APPROVAL: CHIEF SIGNAL DESIGN SECTION		REVISIONS		STATE OF MARYLAND DEPARTMENT OF TRANSPORTATION STATE HIGHWAY ADMINISTRATION BUREAU OF TRAFFIC ENGINEERING OFFICE OF TRAFFIC	
APPROVAL: DISTRICT ENGINEER - TRAFFIC				MD 700 AT KELSO/CEEDAR DRS.	
APPROVAL: CHIEF - BUREAU OF TRAFFIC ENGINEERING				SCALE: 1" = 20' DATE: 6/11/85 CONTRACT NO. B-809-501-485	
APPROVAL: DEPUTY CHIEF ENGINEER OFFICE OF TRAFFIC				DRAWN BY: M. SCHNEIDER COUNTY: BALTO.	
				DESIGNED BY: E. Milesky SIGNAL NO.: 03155	
				CHECKED BY: [Signature] DRAWING NO. TS-2088A

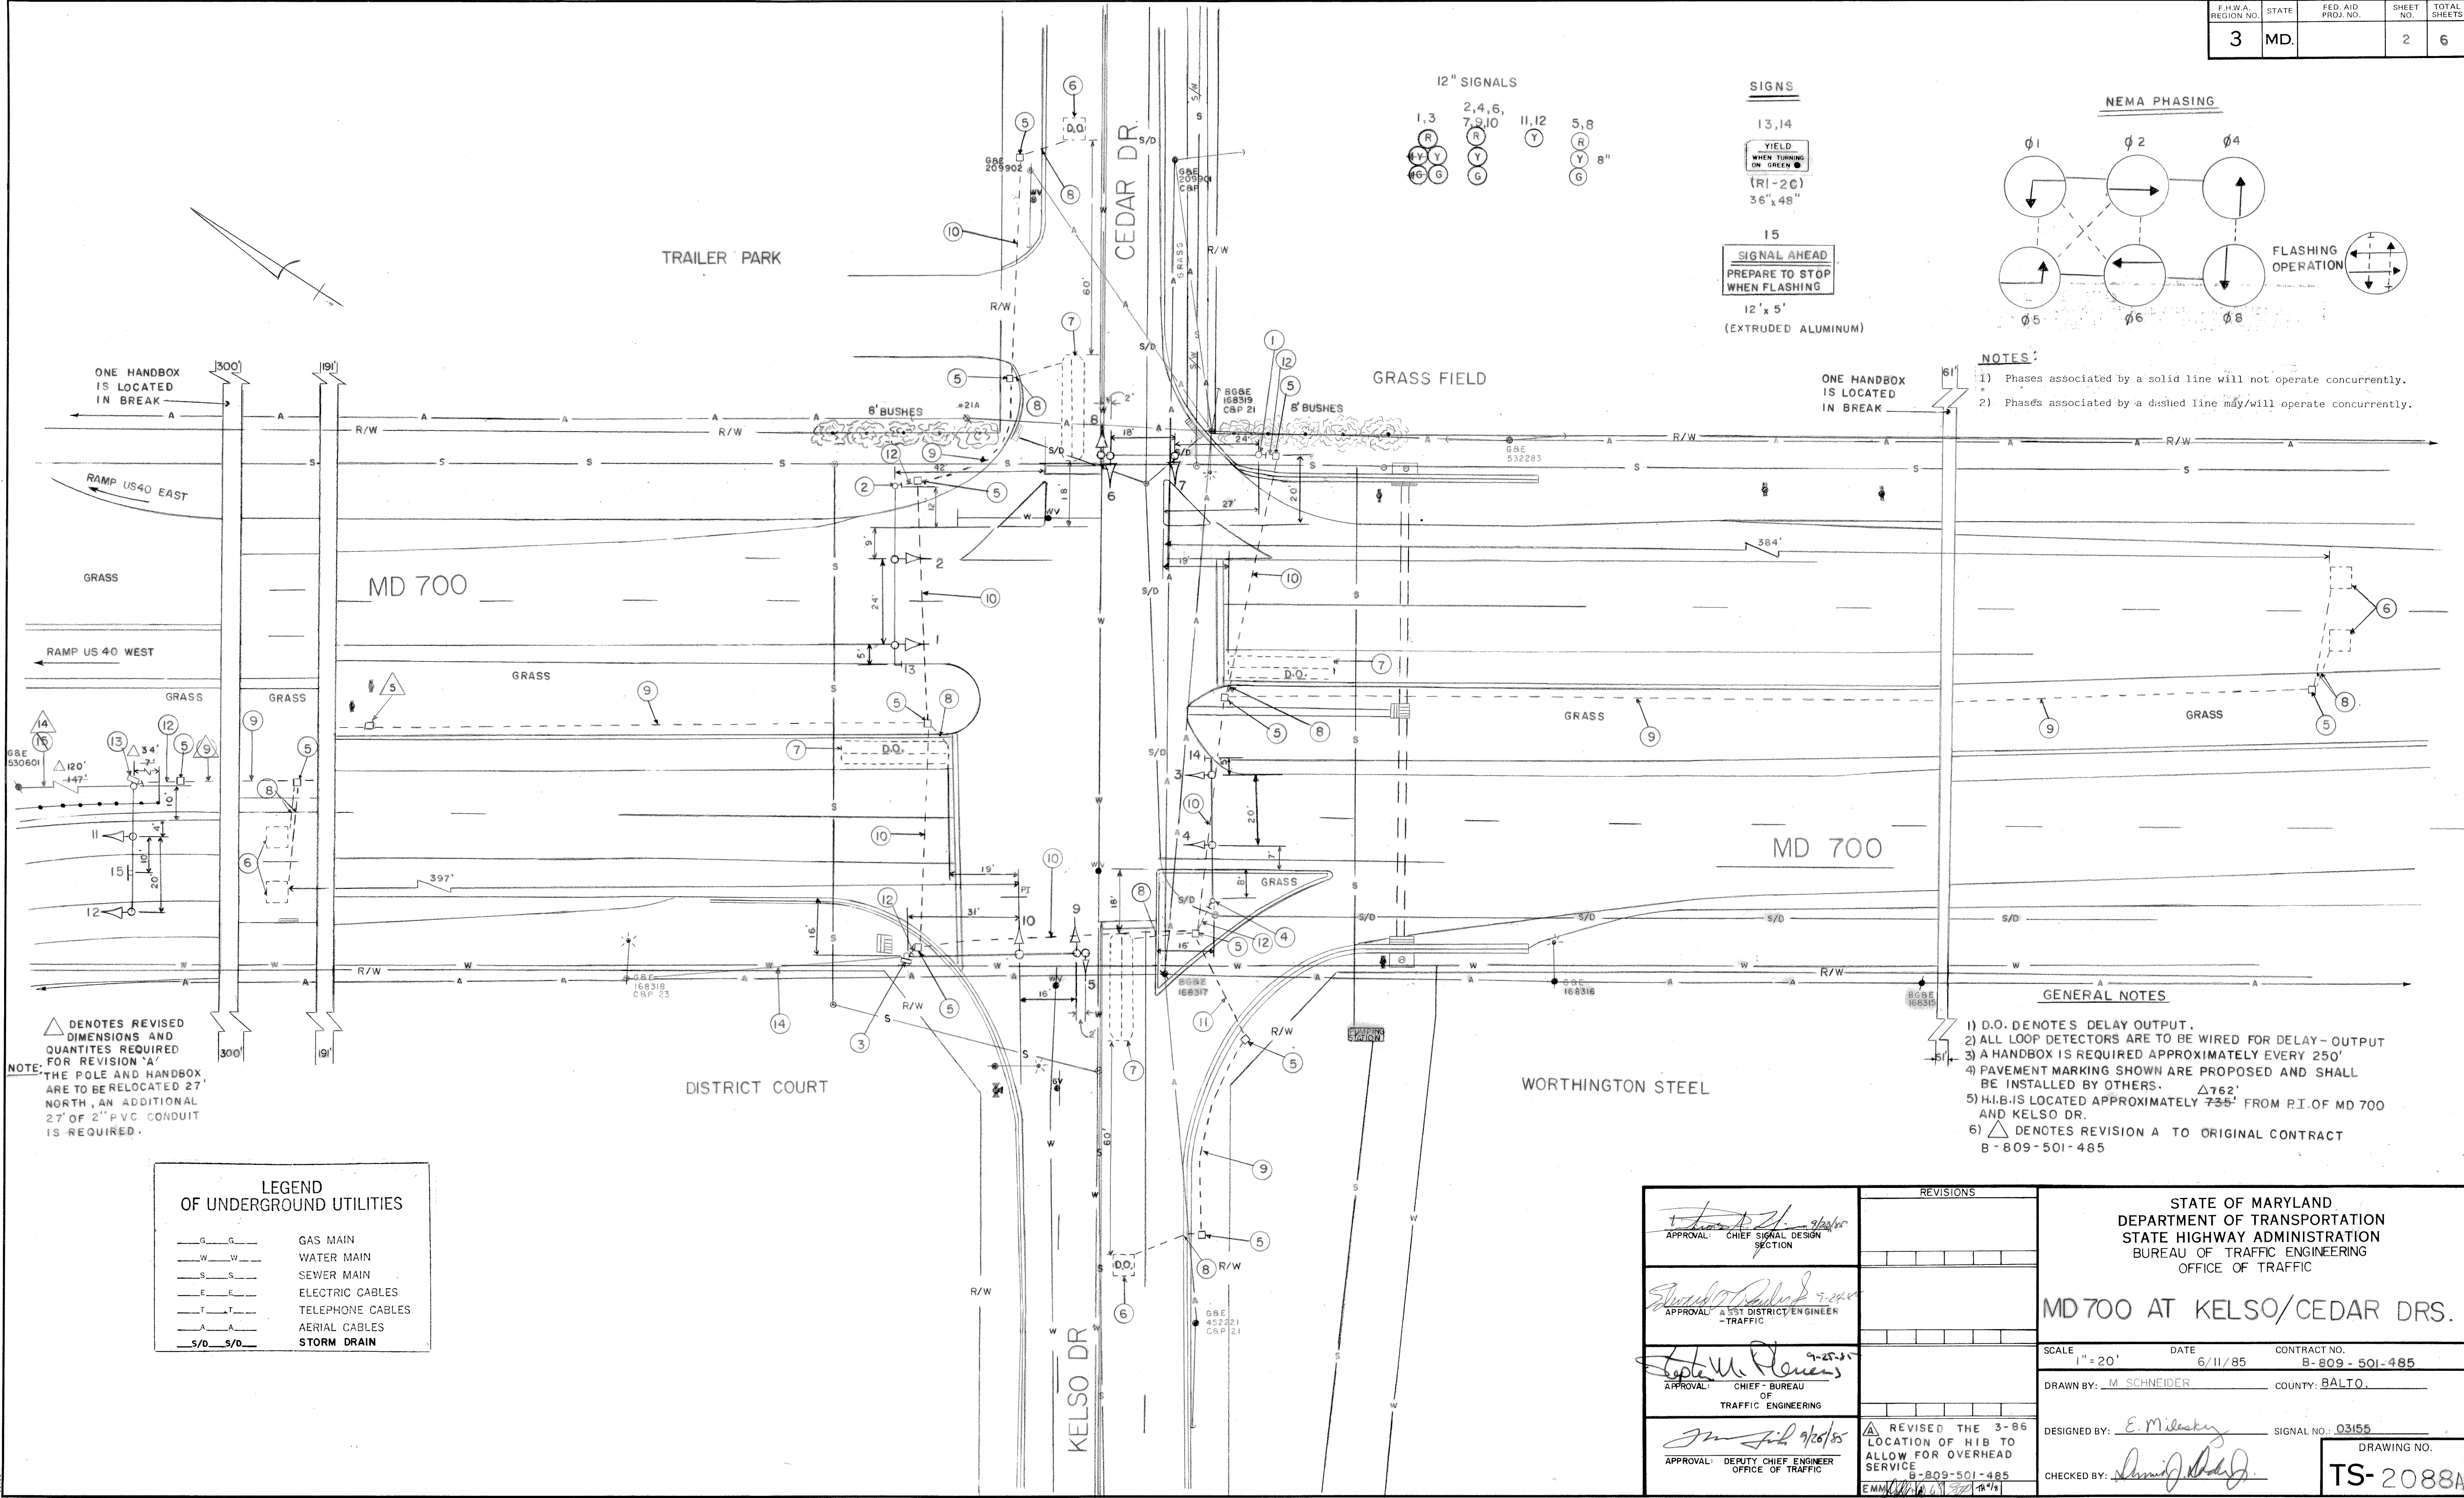
NOTE: Δ DENOTES REVISED DIMENSIONS AND QUANTITIES REQUIRED FOR REVISION 'A'. THE POLE AND HANDBOX ARE TO BE RELOCATED 27' NORTH, AN ADDITIONAL 27' OF 2" PVC CONDUIT IS REQUIRED.

- GENERAL NOTES
- 1) D.O. DENOTES DELAY OUTPUT.
 - 2) ALL LOOP DETECTORS ARE TO BE WIRED FOR DELAY-OUTPUT
 - 3) A HANDBOX IS REQUIRED APPROXIMATELY EVERY 250'
 - 4) PAVEMENT MARKING SHOWN ARE PROPOSED AND SHALL BE INSTALLED BY OTHERS. $\Delta 762'$
 - 5) H.I.B. IS LOCATED APPROXIMATELY 735' FROM P.I. OF MD 700 AND KELSO DR.
 - 6) Δ DENOTES REVISION A TO ORIGINAL CONTRACT B-809-501-485
